**NSLPP MEETING HELD ON 01/12/2021****Attachments:**

ADDRESS/WARD: 8 Baden Road, Kurraba Point (V)**APPLICATION No:** D206/21**PROPOSAL:** Alterations and additions to a heritage listed dual occupancy including an attic addition and partial enclosure of ground floor verandah.**PLANS REF:**

OWNER: Gail Pemberton**APPLICANT:** Anne Colville**AUTHOR:** Robin Tse, Senior Assessment officer**DATE OF REPORT:** 22 November 2021**DATE LODGED:** 8 July 2021**RECOMMENDATION:** Refusal

Figures 1 – 4 : Proposed development

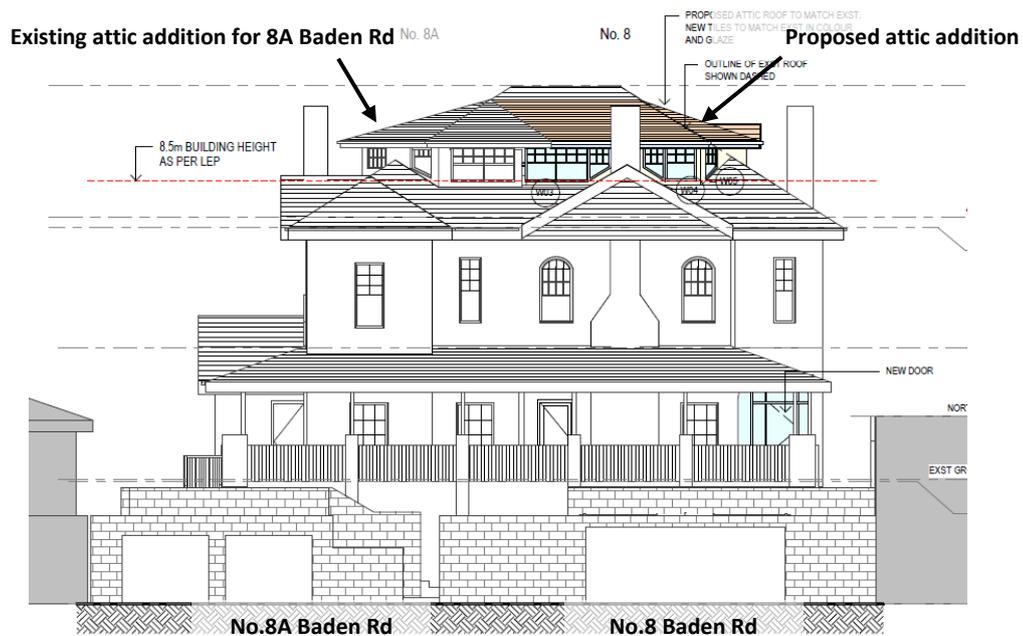
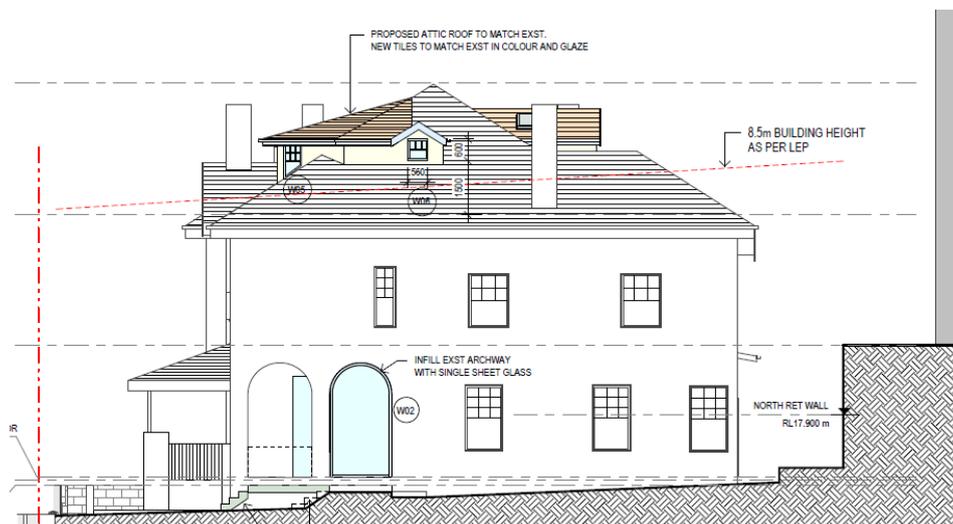
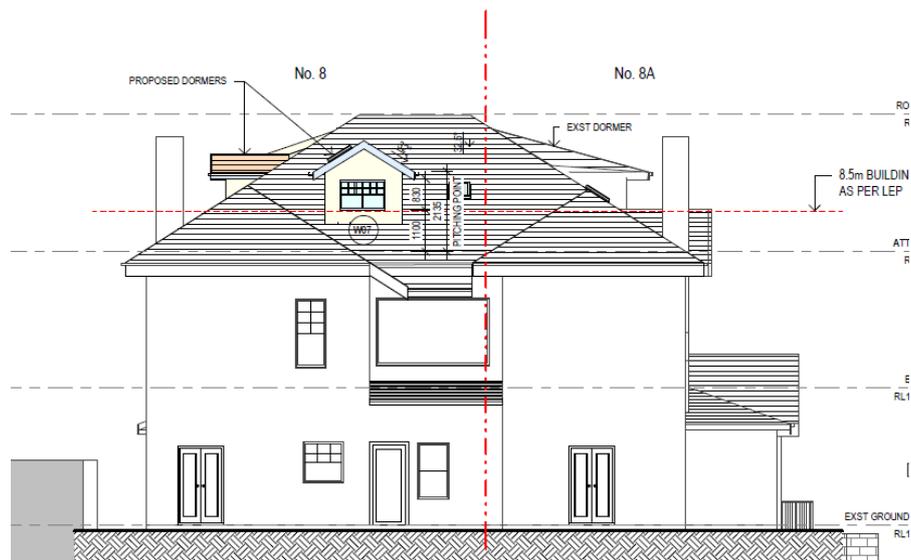
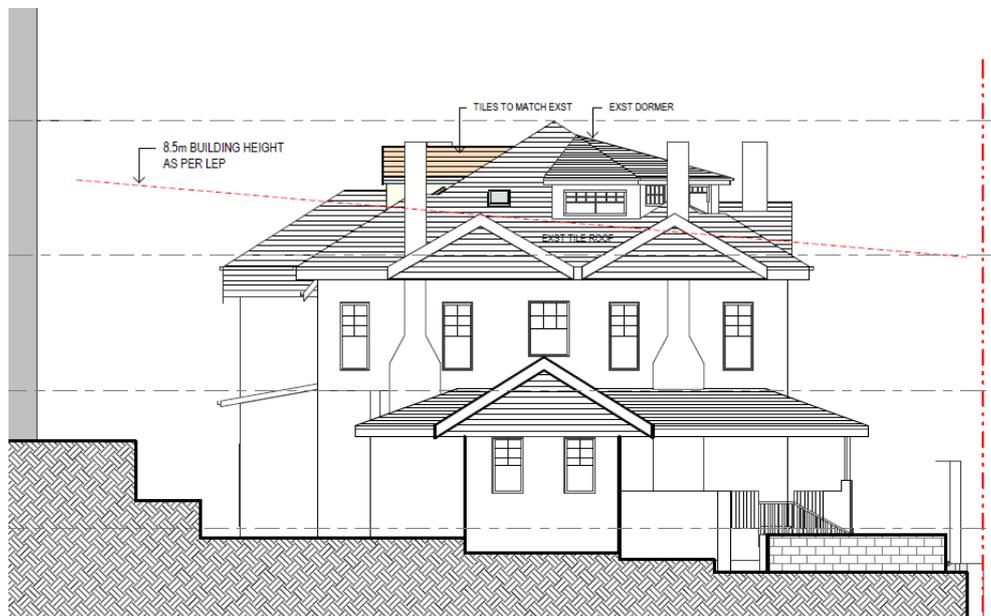
While the existing dormer at 8A Baden is perceived as a minor accretion to the roof form, the proposed roof addition on the amended plans will still result in additional bulk which will be perceived as a whole new level and an alteration in the scale of the building from two storeys to three storeys.

In addition, the ground level verandah will be partially enclosed resulting in further modifications to the primary façade of the dwelling. The design similarity with the adjacent mirror reversed building 1/6 and 2/6 Baden Road will therefore be further altered thus detracting from the heritage significance of the group of heritage items.

13.5.3 Additional Storeys – Objective O1 To minimise the visual dominance of any new work from public places -The amended proposal does not comply as the proposed attic level addition will link with the existing dormer on 8A Baden Road, creating a full floor addition. This will visually dominate the roof plane as it will be forward of the primary roof ridge and will be visible from the public domain.

13.5.4 Roofs – Objective O1 To ensure that original roofs, their hierarchy and materials are maintained -The proposal does not comply as the proposed works to the attic will visually dominate the primary roof plane and will be forward of the primary roof ridge.

Figure 12: Attic addition at No.8A Baden Road

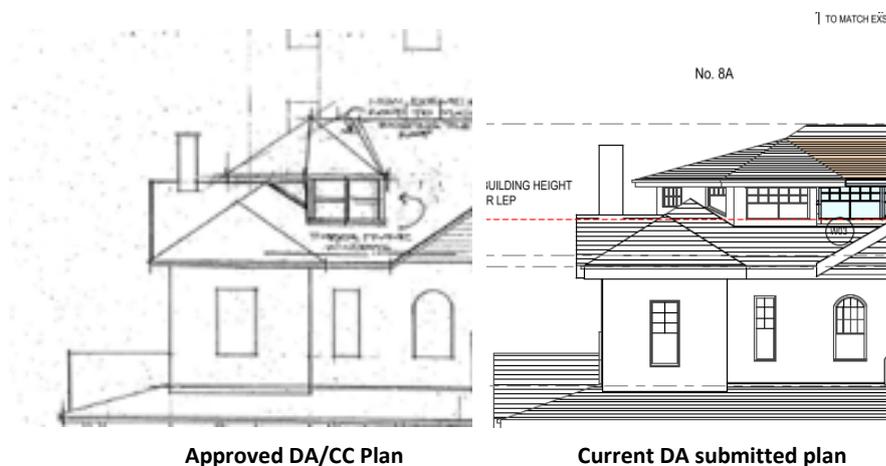
The proposal seeks to further detract from the building's heritage significance. The existing attic conversion on 8A Baden Road is perceived from the street as a single dormer and is read in the context of the front roof plane of the whole building, not just 8A. The dormer on 8A Baden Road is also similar to that at 1/6 Baden Road which was constructed prior to 2000, prior to the existing heritage controls being adopted.

The amended proposed new attic works however, will still result in the existing dormer at 8A being read as part of a full floor roof addition, as the addition will extend across the majority of the front roof plane forward to the primary roof ridge and wrap around the side. This will result in the building being perceived as three storeys in scale, rather than two storeys. This will detract from the aesthetic significance of the primary façade.

Figure 13: Proposed building height

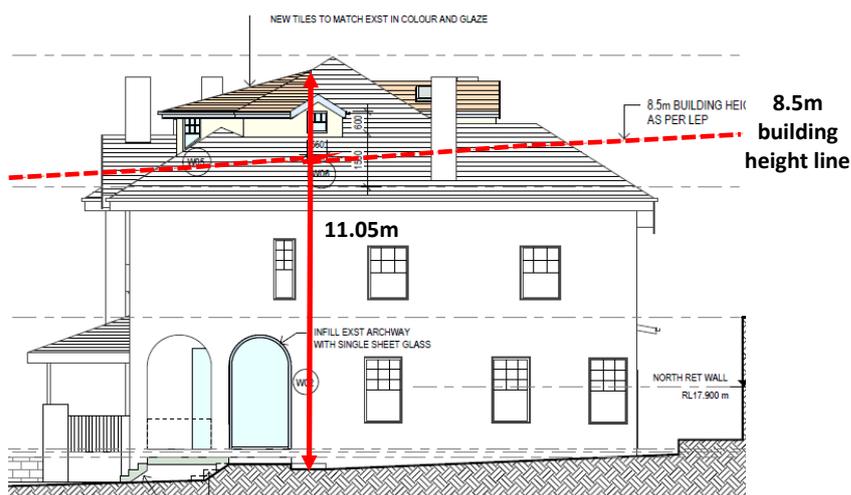
The height of the existing dual occupancy does not comply with the maximum building height control pursuant to Clause 4.3(1) of NSLEP 2013. The maximum height of the proposed works (roof of the attic addition) at 11.05m and the new dormer on the western (rear) roof plane would breach the LEP building height control as illustrated below in **Figure 13** below:

It is concluded that the building element above the LEP building height limit would have a material impact on the neighbouring properties and the locality in terms of uncharacteristic built forms and having a detrimental impact on the significance of the subject building and the heritage listed dual occupancy at the adjoining property to the south (No.6 Baden Road) and the amenity of the nearby residential properties. There are insufficient environmental planning grounds to justify contravening the building height control.

Figures 15 & 16: Views from a balcony of a townhouse unit at No.192 Kurraba Road

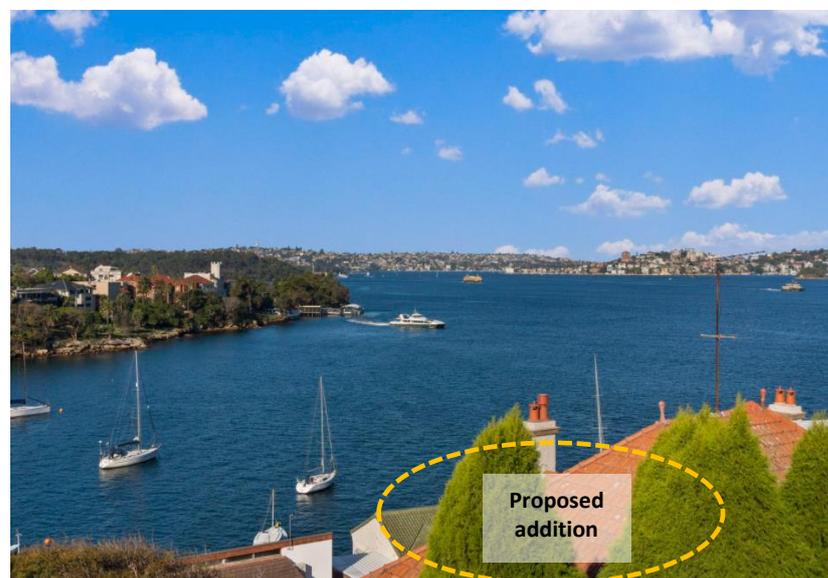
A real estate photograph taken from the balcony of the townhouse at the southern end of the development indicates that the proposed works is likely to cause an obstruction to some water views as seen from this unit, however, the impacts would be largely screened by existing vegetation along the side property boundary.

Figure 17: View from the window of the northern bedroom within Unit 3 147 Kurraba Road

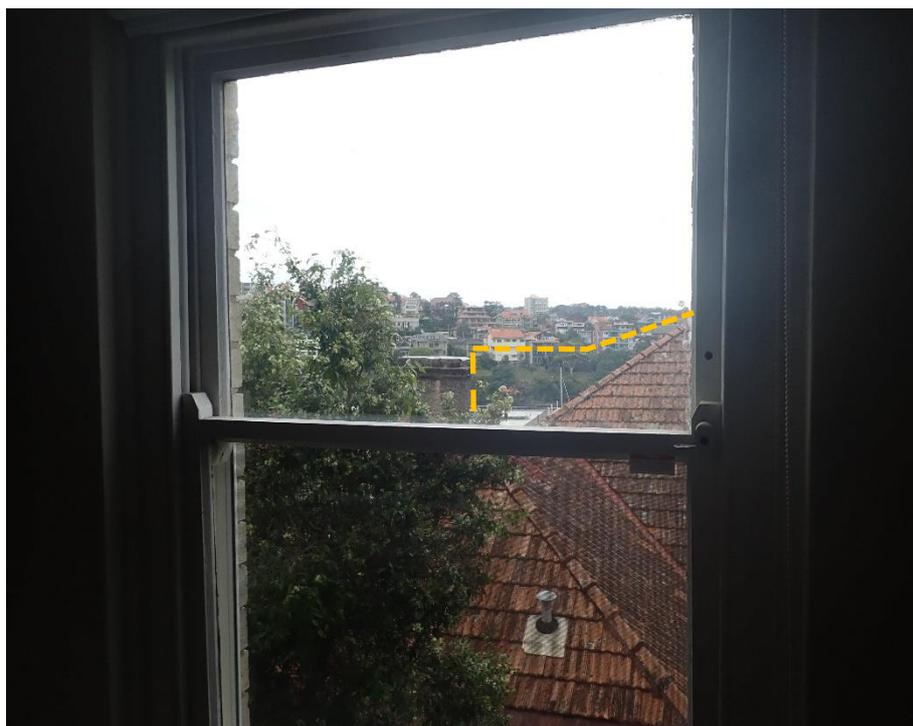
The proposed attic addition would cause partial obstruction to the district views of Cremorne Reserve with the retention of the skyline as indicated in **Figure 17**.

Figure 20: View from the middle bedroom window within Unit 5 147 Kurraba Road

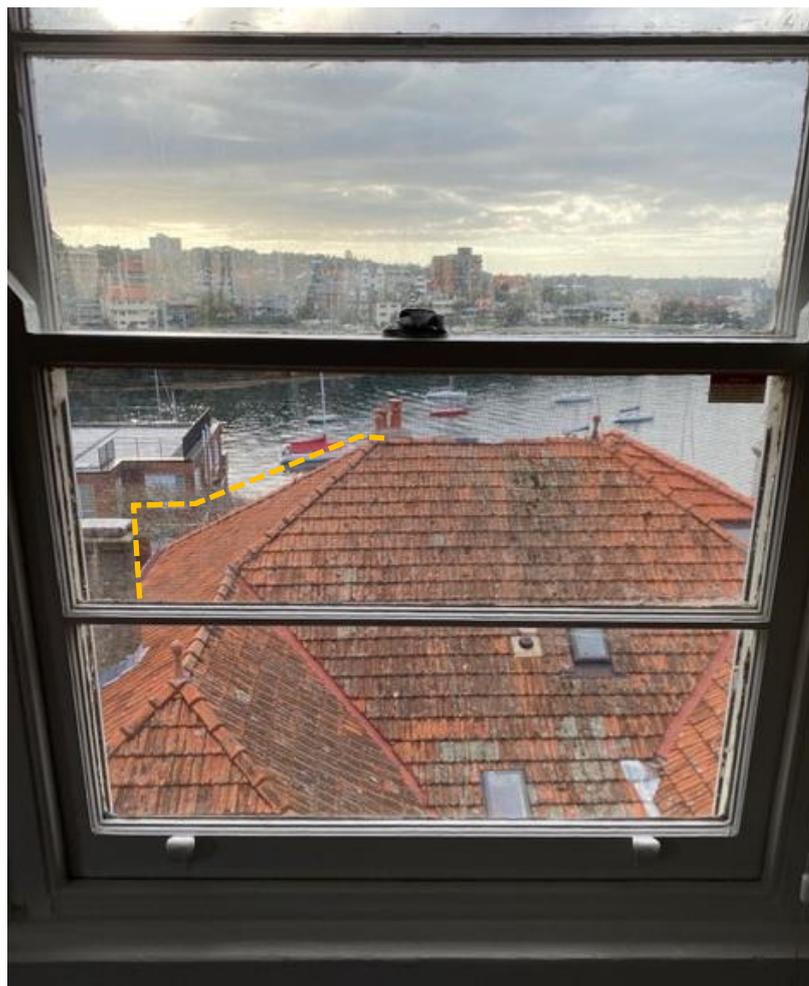
The proposed attic addition would cause partial obstruction to the water views of Shell Cove with the retention of the remaining water views, water and land interface and the view of Cremorne Point skyline as indicated in **Figure 20**.
